# 2018 - 2019 Cadillac ATS-V - CTS-V: Service Bulletin: #20-NA-054: Rear View Camera Guidance Lines Dim After Radio Replacement or Programming

## #20-NA-054: Rear View Camera Guidance Lines Dim After Radio Replacement or Programming - (Mar 3, 2020)

**Subject:** Rear View Camera  
Guidance Lines Dim  
After Radio Replacement  
or Programming

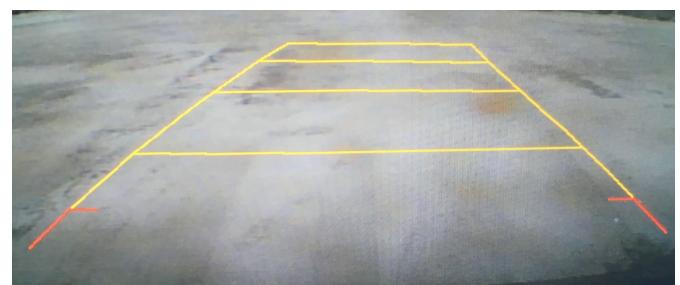
Some customers, after having radio replacement or radio reprogramming, may report that the Rear-View Camera (RVC) guidance lines are not as bold

as previously viewed, that they are faint, see-through, thinner, dim, or translucent; and they used to be more visible. A comparison between similar vehicle models may, or may not, show a difference in rear view camera guidance line appearance.

This may be caused by installing calibration files released in mid-2018 during radio replacement or reprogramming of the radio. The change to increase translucency was done to prevent the lines from

obstructing objects in the field-of-view.

Do not attempt repairs. The thinner, lighter appearance of RVC guidance lines is operating to design intent.
